RE: UNM North 4th St Clinic
3401 4th St NW
Grading Plan Stamp Date: 6/25/18
Hydrology File: G14D086

Based on the submittal received on 8/6/18, this project cannot be approved for SO-19 Permit until the following are corrected:

GRADING PLAN
UNM NORTH 4TH STREET CLINIC-GRADING REVISIONS

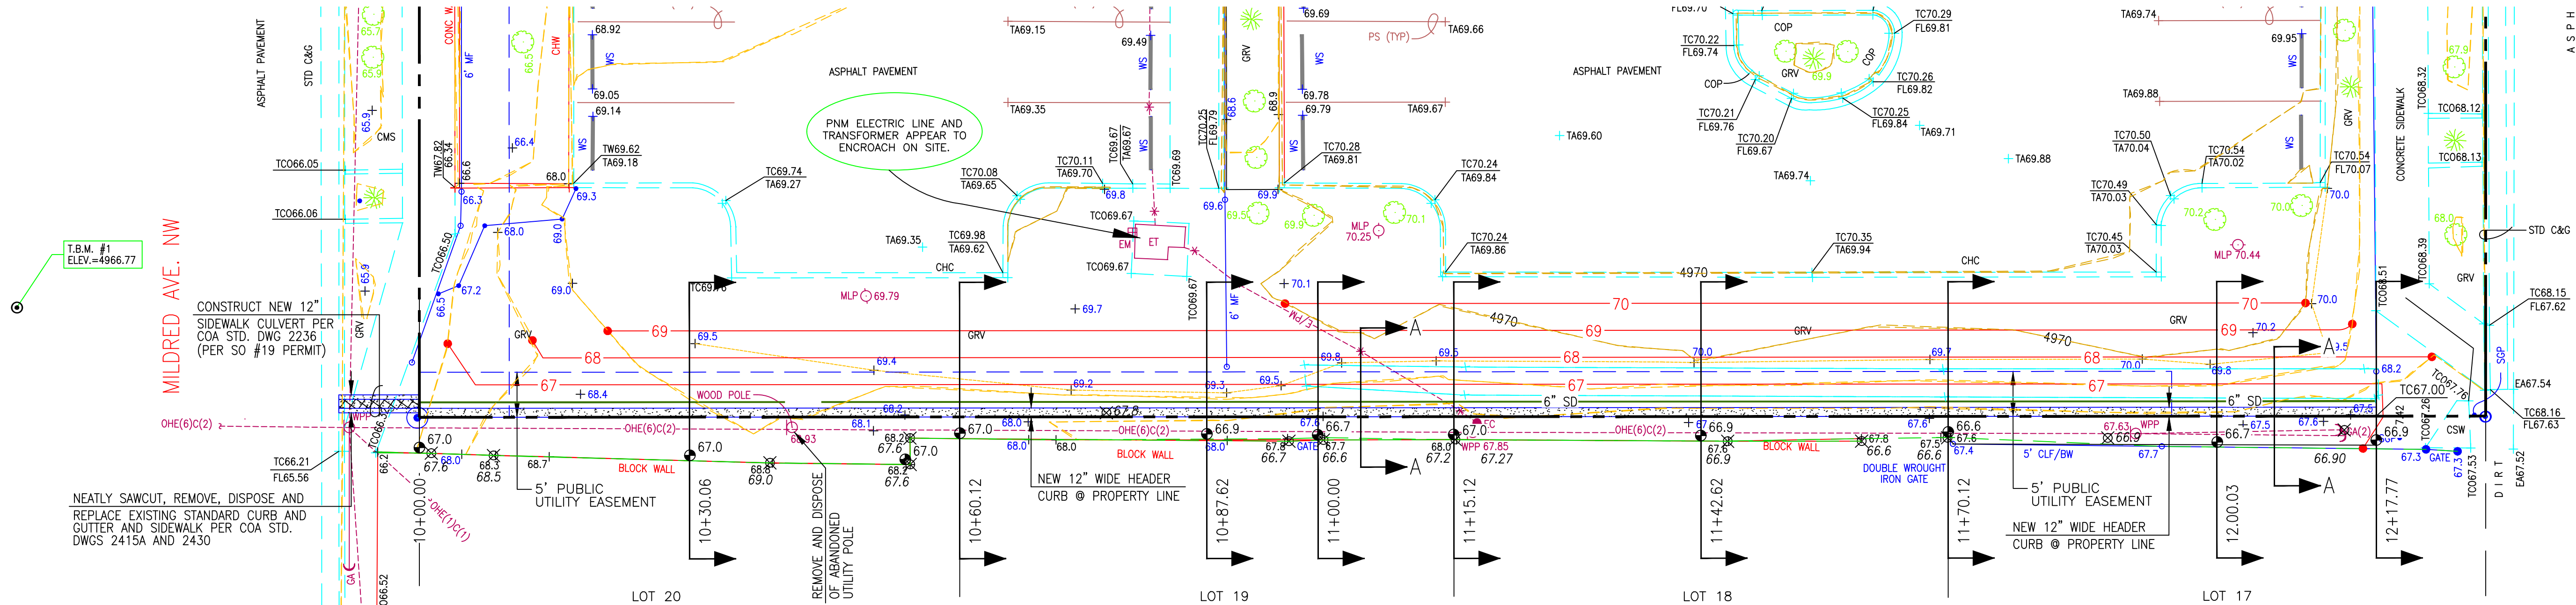
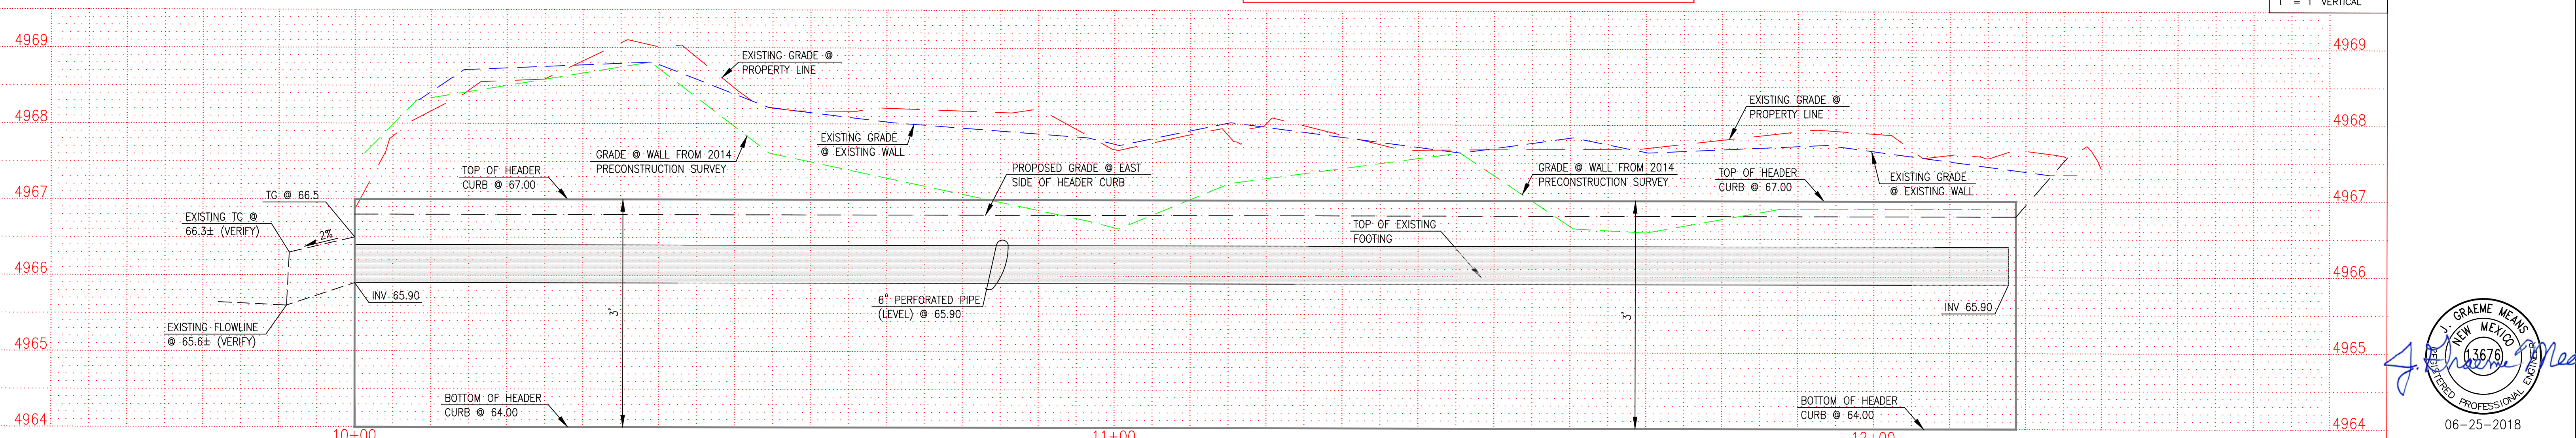
1. Provide a detail for the 6" drain pipe into the back of the sidewalk culvert. It appears a small concrete headwall around the 6" pipe will be needed to keep dirt from flushing into the culvert and to support the abrupt transition in the finished grade at the ROW line.
2. Include the [standard SO-19](#) notes on the grading plan.
3. Use the [current DTIS version](#) (6/2018) when resubmitting.
